Re: Indian Point Unit 2
Docket 50-247

NL-08-101

**SUBJECT: Proposed Changes to Indian Point 2 Technical Specifications
Regarding Diesel Generator Endurance Test Surveillance**

- 1: Analysis of Proposed Technical Specification Changes Regarding Diesel Generator Endurance Test Surveillance
- 2: Markup of Technical Specification Page for Proposed Changes Regarding Diesel Generator Endurance Test Surveillance

FIGURE 27 - TEST 2 LOAD DUTY CYCLE LOWER PHENOLICS

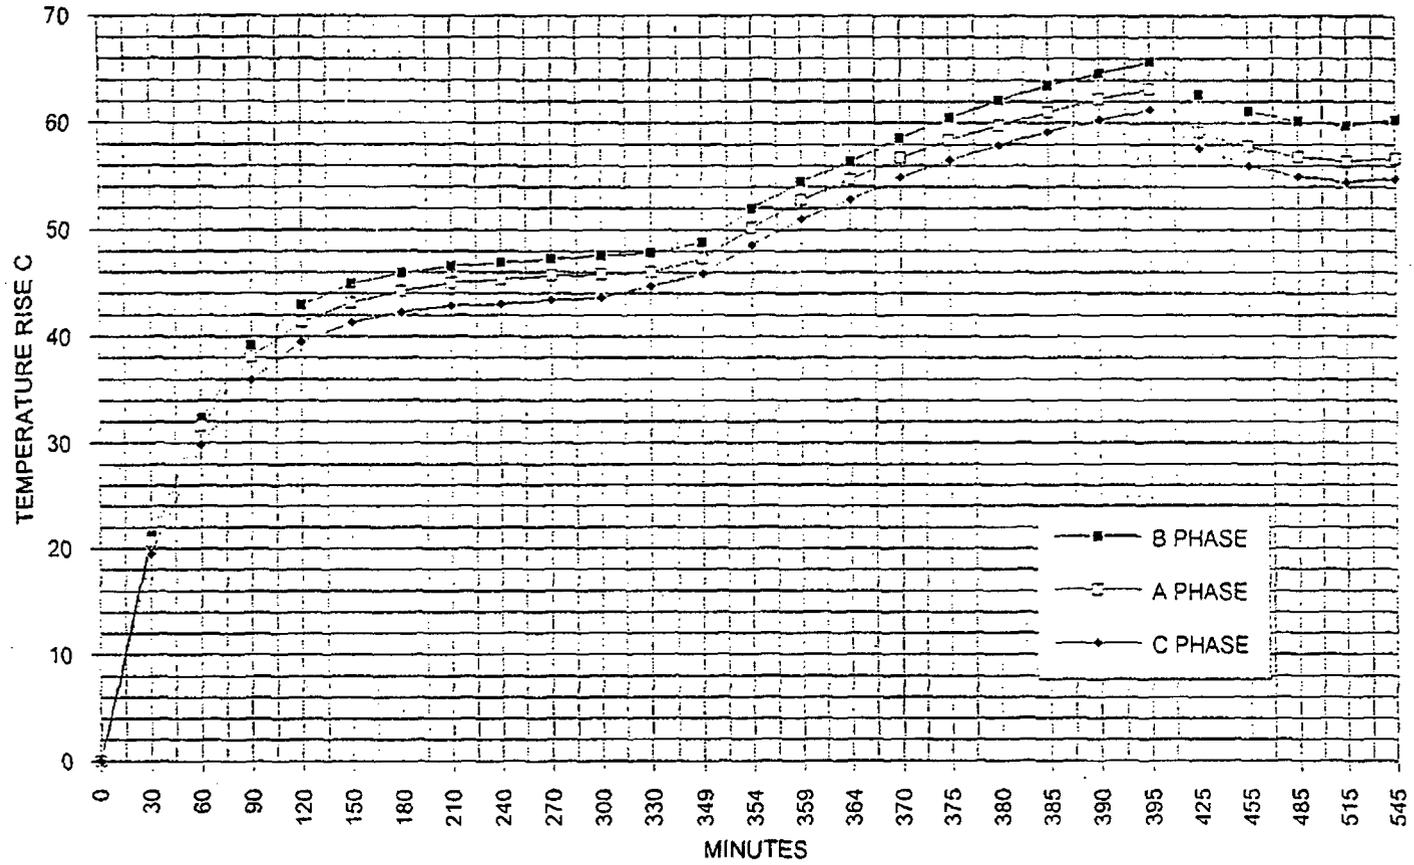
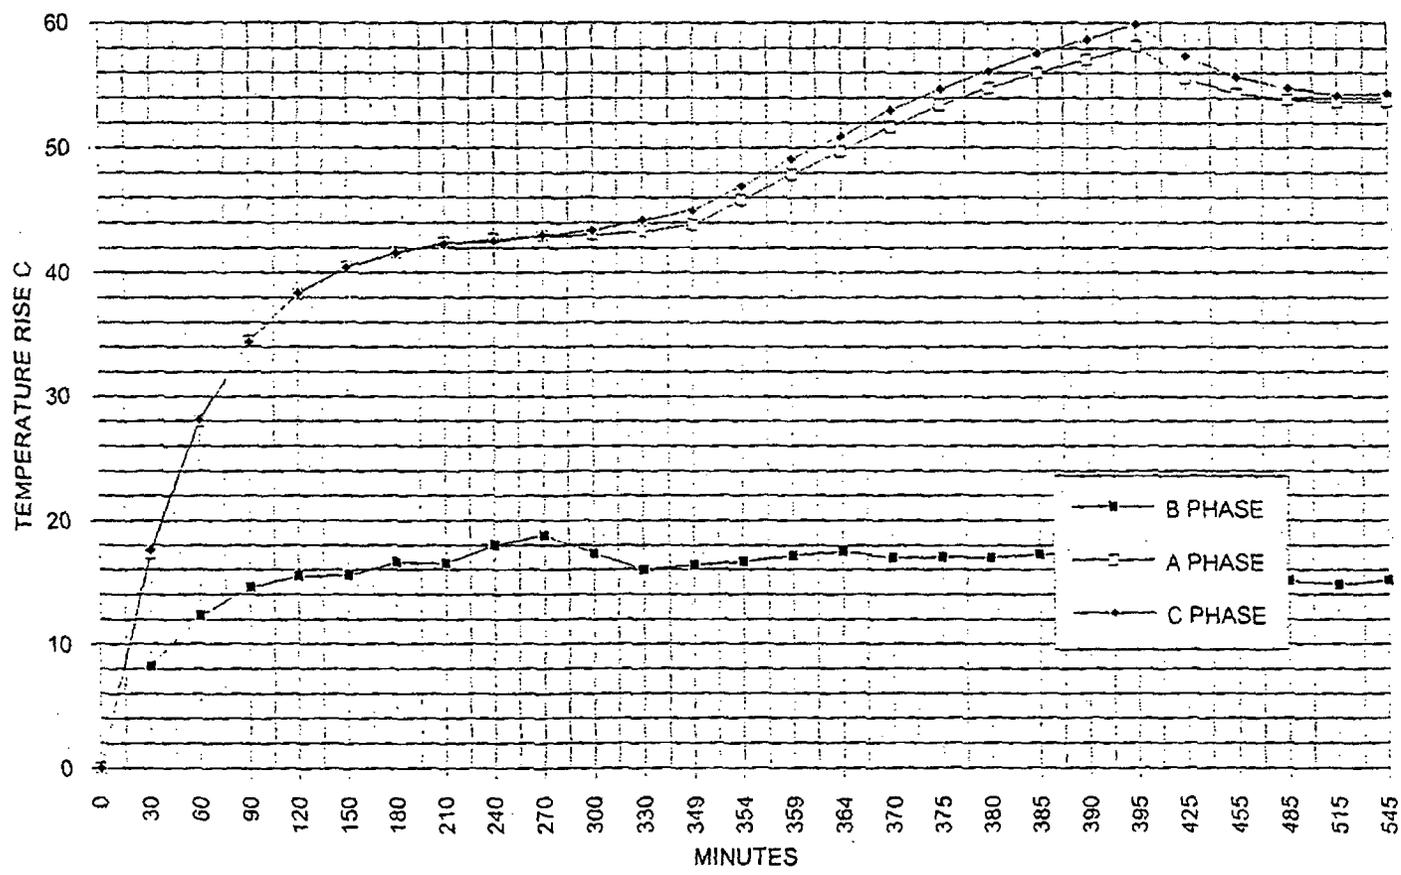
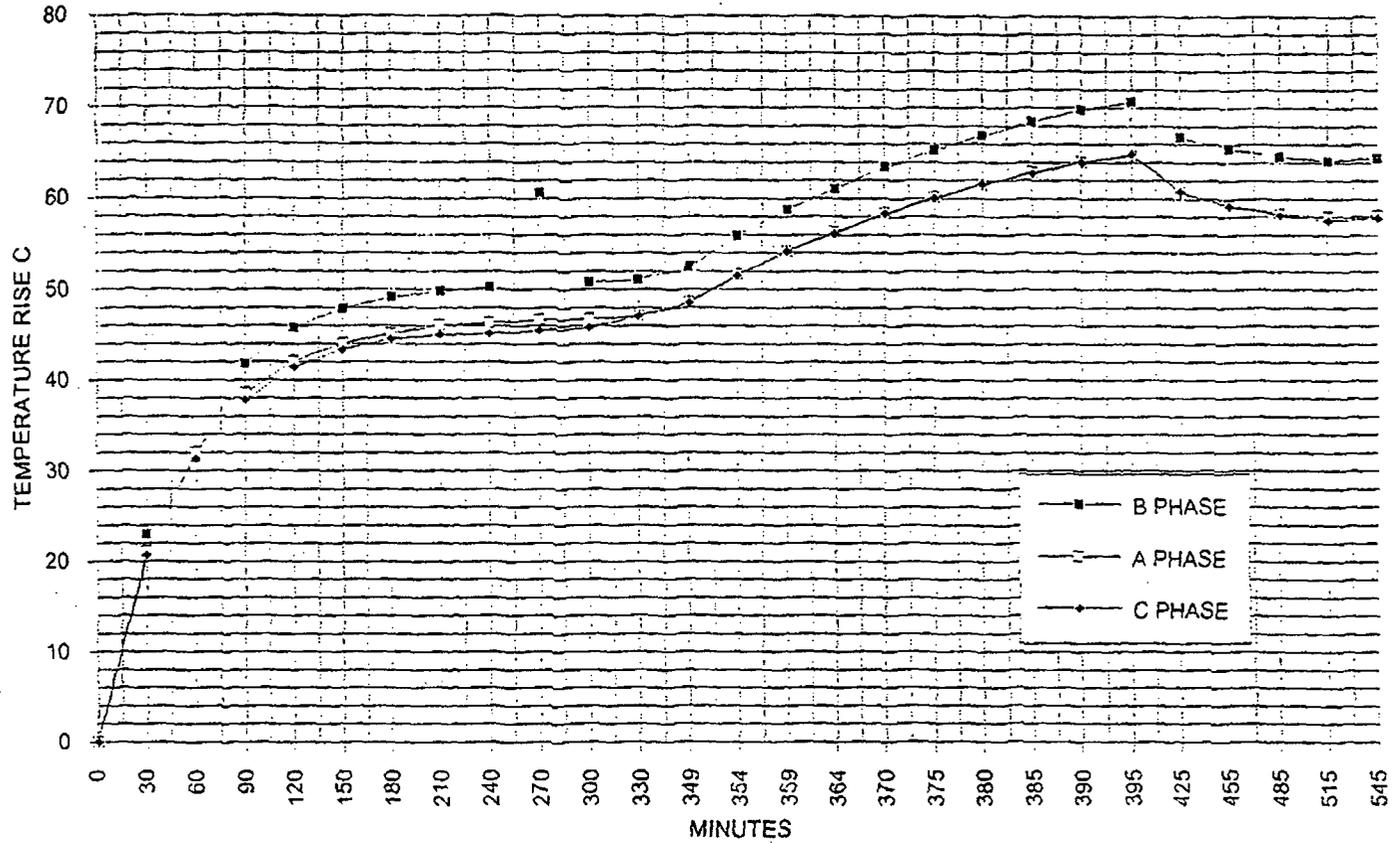
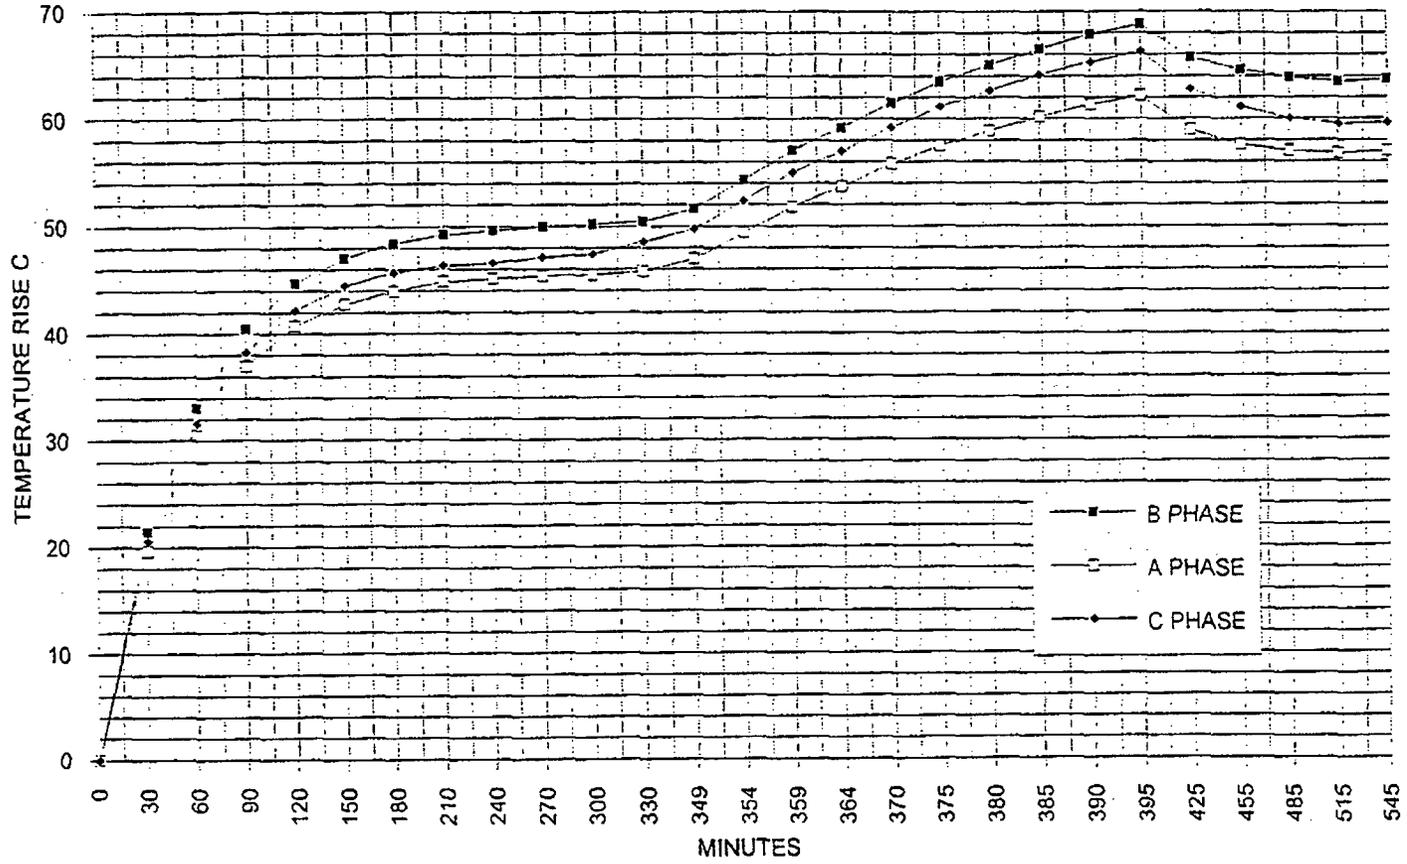
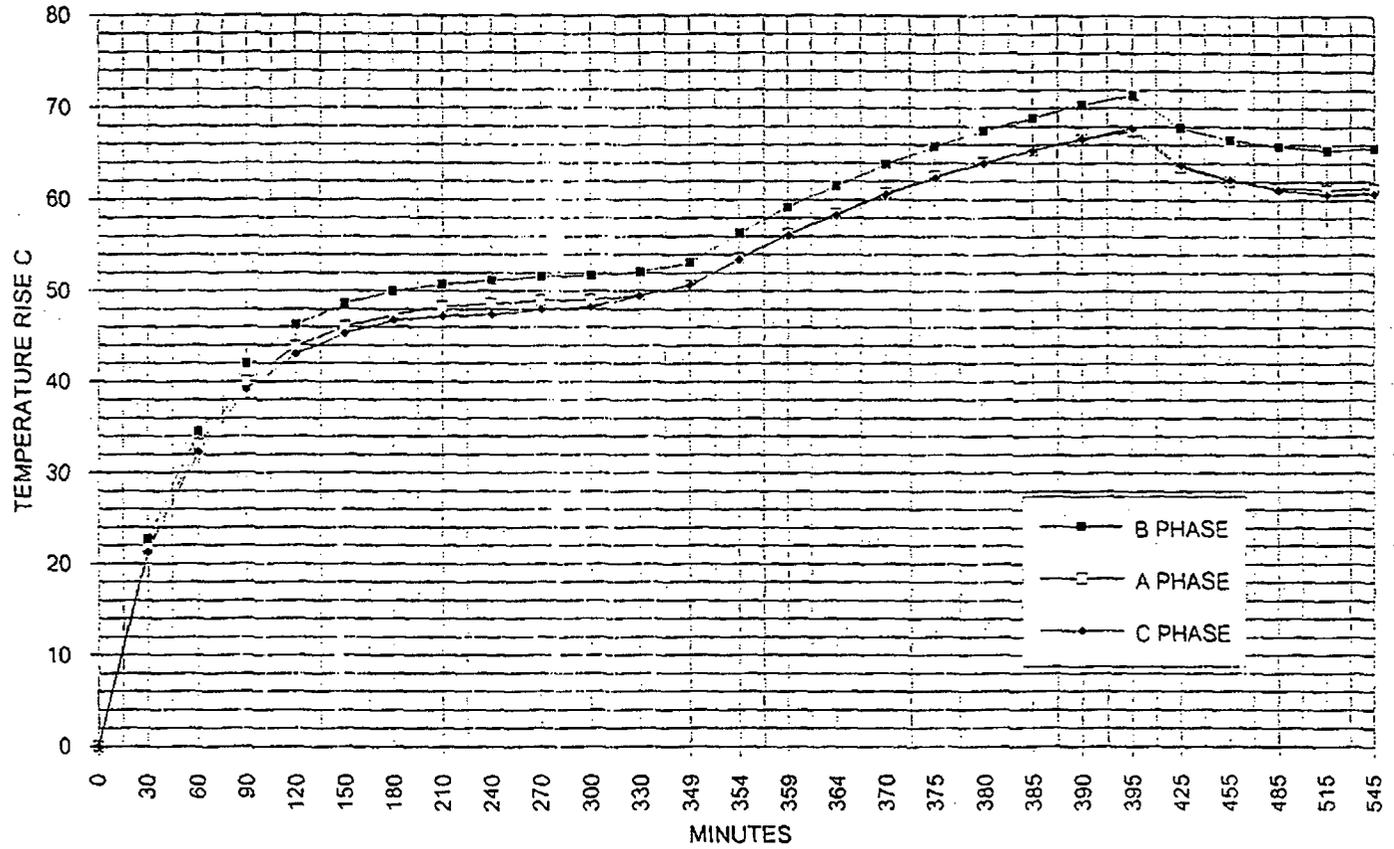
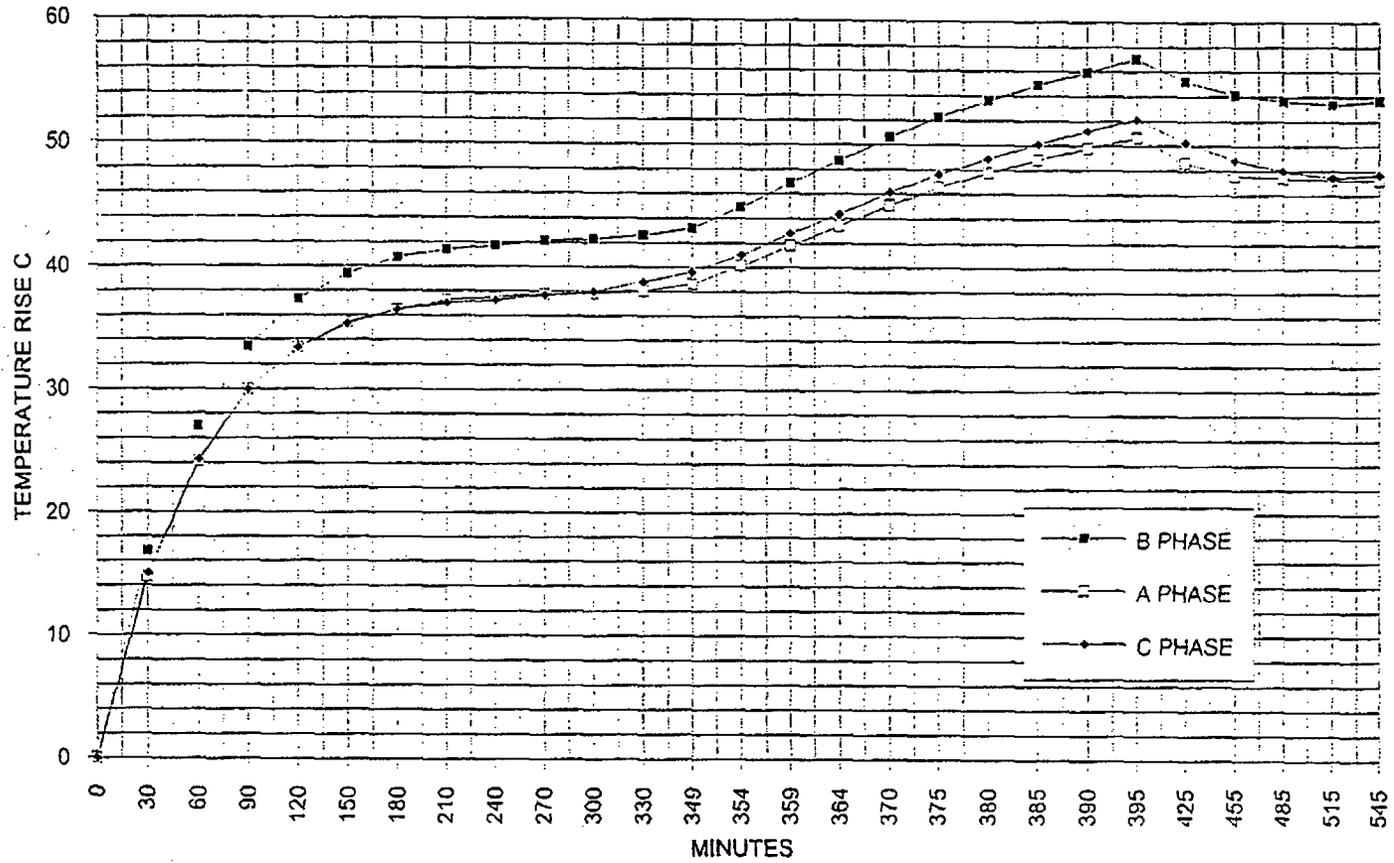
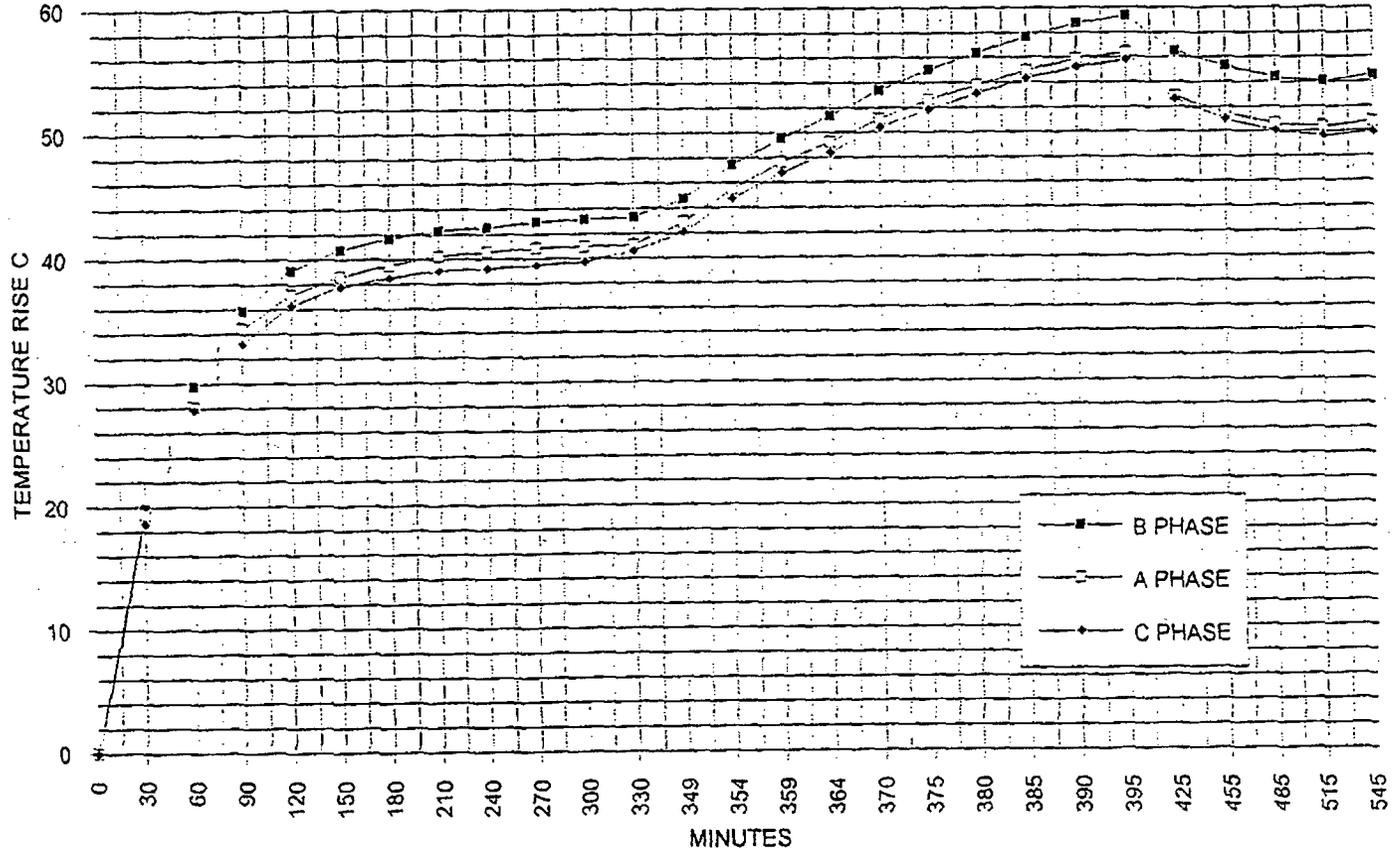
Figures 27 through 34 show the temperature versus time plots for the various breaker points during the load duty cycle. Again the limiting component was the phenolic. At the 349 minute mark the current was raised from 2500 amperes to 3300 amperes. The curve indicates that at the 349 minute mark the temperature was up some. This is due to the way the current was increased. It takes some time to raise the current and balance the 3 phases to about the same value of current. The 349 minute mark is the point in time when all adjustments have been complete. At this point, the timer was started. At the 395 minute mark the phenolic component reached its maximum operating limit. This confirms that the breaker can safely operate for 46 minutes at 3300 amperes after the temperature is stabilized at 2500 amperes. The time associated with reaching the maximum temperature was the actual time and not the time to reduce the current. A review of the curve shows that after the 395 minute mark, the temperature starts to decay even though the current was reduced a short time later. The reason is that the sampling time is every 30 minutes during stability runs, and once the current is reduced, the temperature decays rapidly.
